ADVANCE NOTICE OF REVISION

(This Notice **supplements** all earlier Notices)

REVISION:	DATE: 8/25/97	PAGE: 1 of 3
---	-----------	------------------	-----------------

Figure 1: Revised Wheel Pant Backing Plate Aft Edge Contour

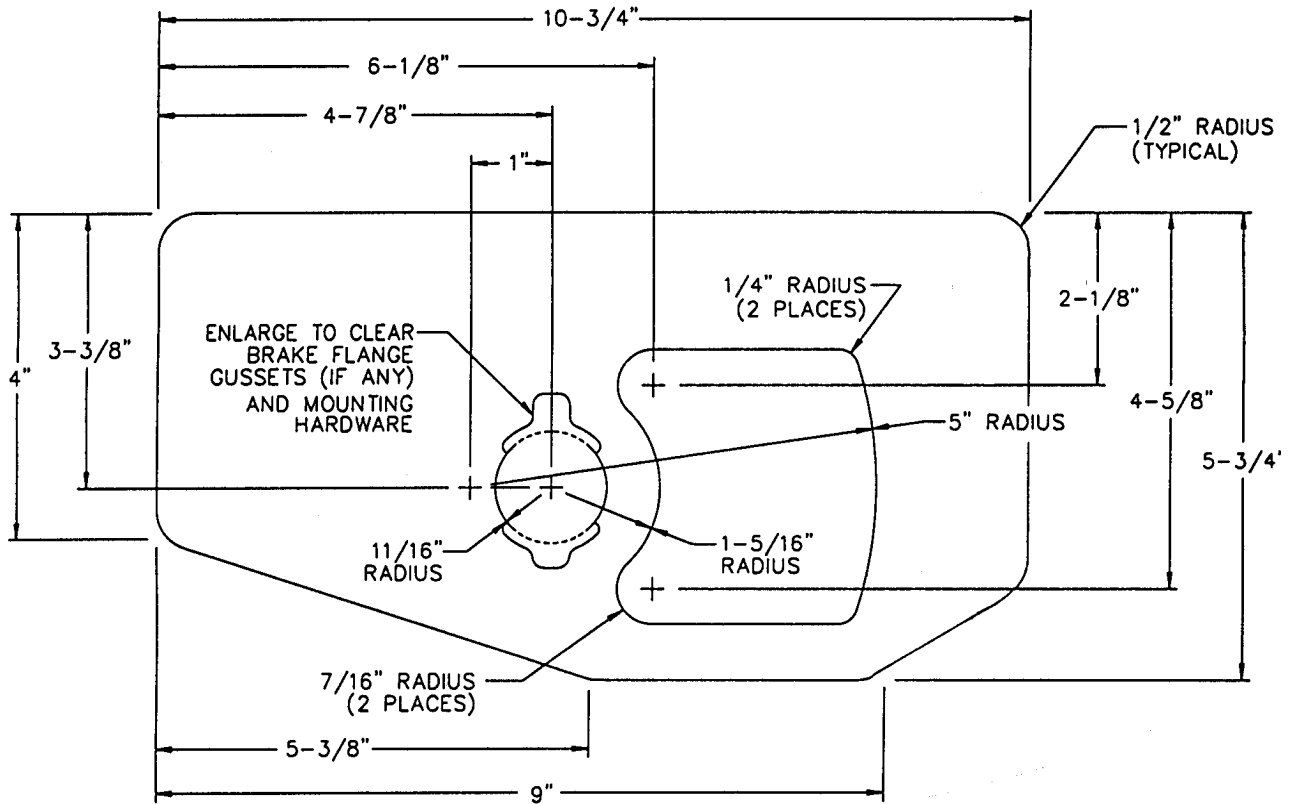
Pages 217: Figure 118 will be changed to show a different contour for the aft edge of the wheel pant backing plate. This new shape is illustrated in Figure 1 of this ANOR.

Figure 2: Revised Wheel Pant Lower Aft Foam Spacer Location

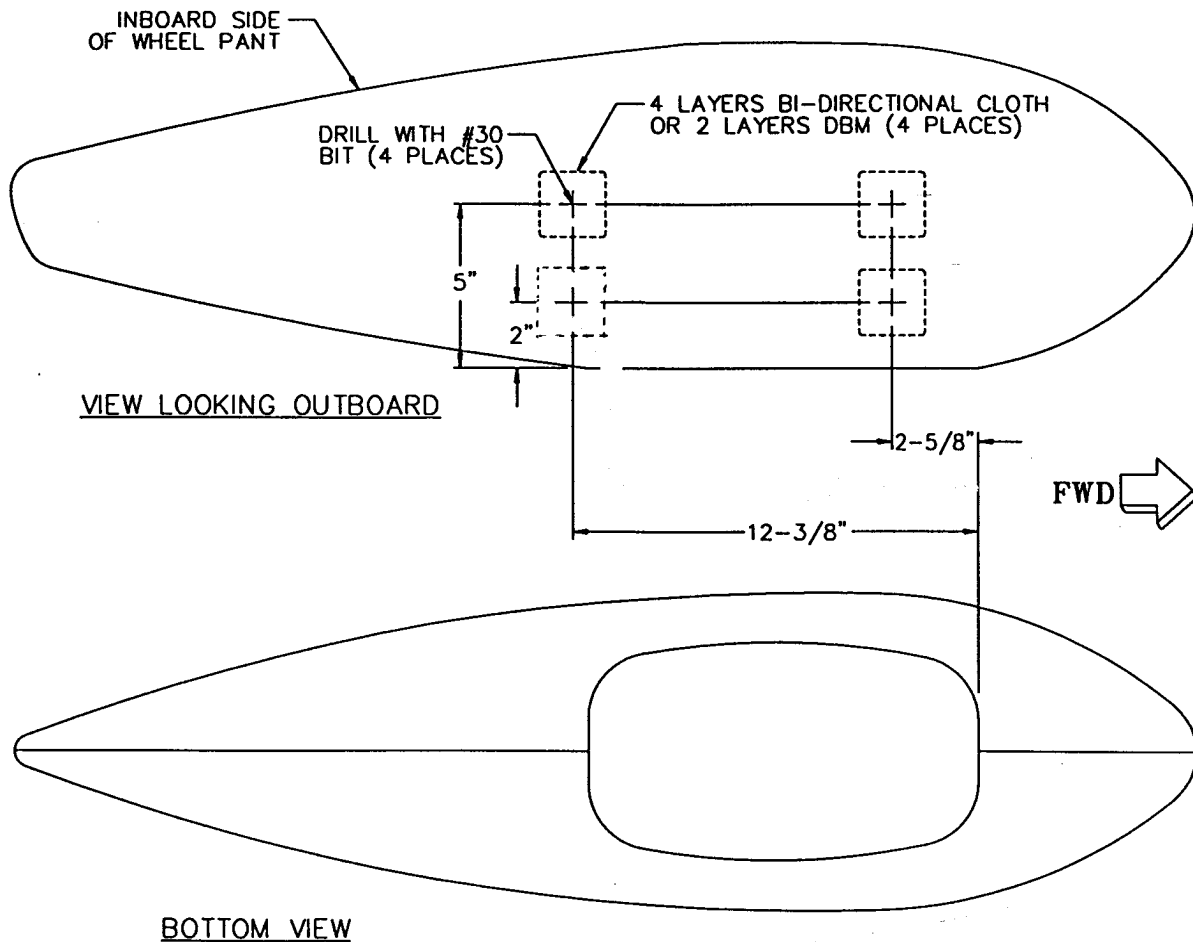
Page 119: Figure 62 will be changed to show a different location for the lower aft foam spacer location. This new location is illustrated in Figure 2 of this ANOR.
